STAFF REPORT: 10/9/2024 MEETING

ADDRESS: 4081 PORTER

APPLICATION NO: HDC2024-00501

SCOPE: PAINT DWELLING AND INSTALL STONE VENEER AT FAÇADE

4081 Porter. Photo by staff taken in August 2024 after unapproved work.

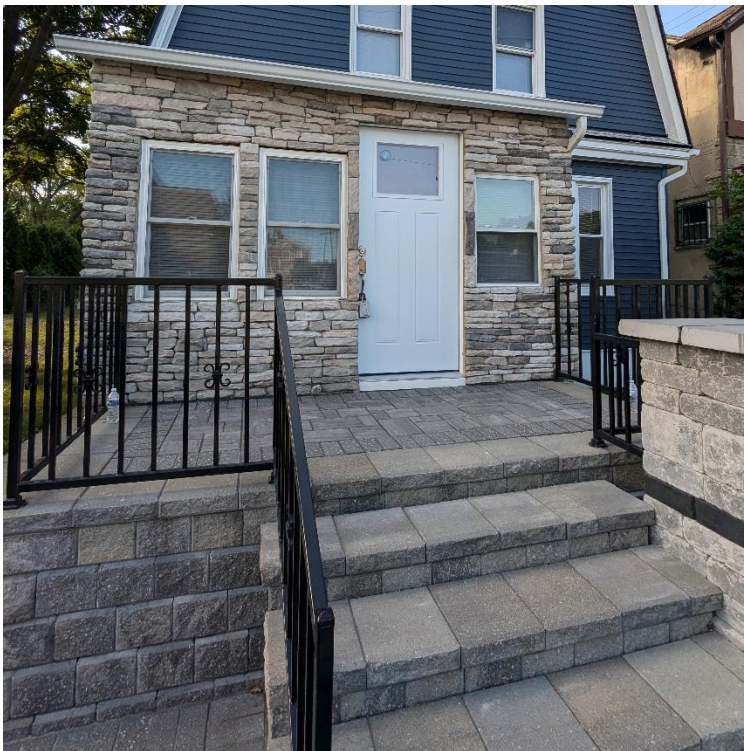
- Regarding the three vinyl windows which were recently installed without HDC approval, staff does note that the wood windows that were removed were likely installed after the district's period of significance and therefore not distinctive character-defining elements that needed to be retained or replicated if replacement was merited due to condition. However, any new windows installed at the dwelling should be compatible with the house's historic character per National Park Service (NPS) guidelines. It is staff's opinion that vinyl windows are incompatible with the historic character of this ca. 1915 historic house for the following reasons;

For these reasons, it is staff's opinion that the three windows which were recently installed at the enclosed front porch do not meet the Standards. Staff does note that several other vinyl windows exist at the dwelling's exterior. As previously noted, these inappropriate windows were installed without HDC approval sometime before 2007. It is staff's opinion that any new windows which shall be installed at the property should be composed of a material which presents a more accurate replication of wood windows in order to forestall further diminution of the building's historic character.

Recommendation #1 - Section 21-2-78 -Denial – Install three vinyl windows and masonry cladding at enclosed front porch; install a masonry front porch/deck at primary entrance; install masonry paver patio and walkway at the front yard

4081 Porter, detail of new masonry porch/deck. Photo by staff taken in August 2024 after unapproved work.

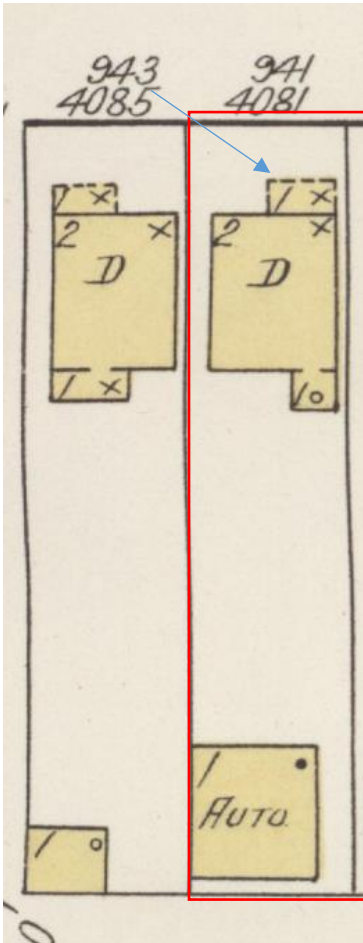
- Similarly, it is staff's opinion that the new masonry front porch deck and paver patio do not conform to the Standards and district's Elements of Design as they present a modern expression of masonry that is incompatible with the property's historic character. Also, regarding the new porch/deck, note that it replaced a small set of wood steps which extended well south of the sidewalk and north property line, which was in keeping with the established setback along the block. Although the other porches within the same block are all open, they each do include a similarly dimensioned set of steps which lead from the porch to the front yard beyond, leaving a comfortable amount of space between the edge of the steps and the sidewalk. However, due to the large size of the current porch/deck, the steps push well north of the datum established by the historic front porch steps in the near vicinity, with the bottom step landing only inches south of fence and sidewalk beyond. This is inconsistent with the existing porches within the district and the property's near vicinity.

- Also, the due to the large size of the porch/deck, the steps extend well north of the datum established by the historic front porch steps in the near vicinity, as the bottom step lands only inches south of fence and sidewalk beyond. This is inconsistent with the existing porches within the district and the property's near vicinity.

1921 Sanborn map

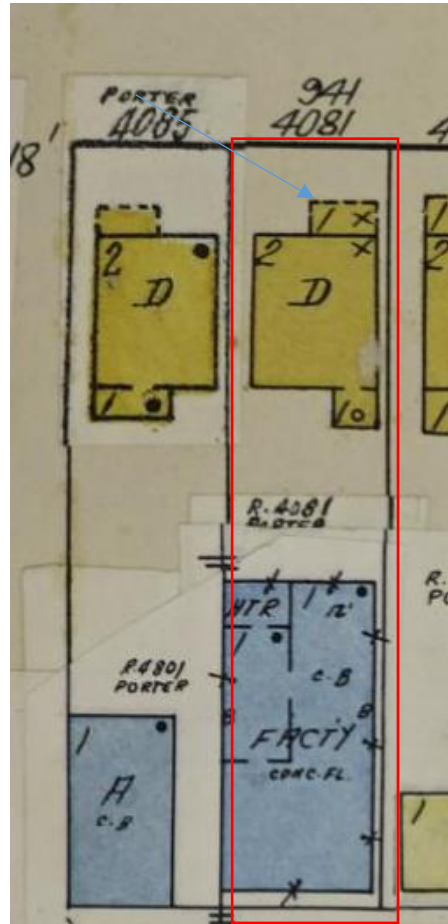
- Please see the below Sanborn Fire Insurance maps which indicate that the front porch was open in 1921, 1951, and 1971 (4081 Porter is outlined in red, blue arrows show porch)
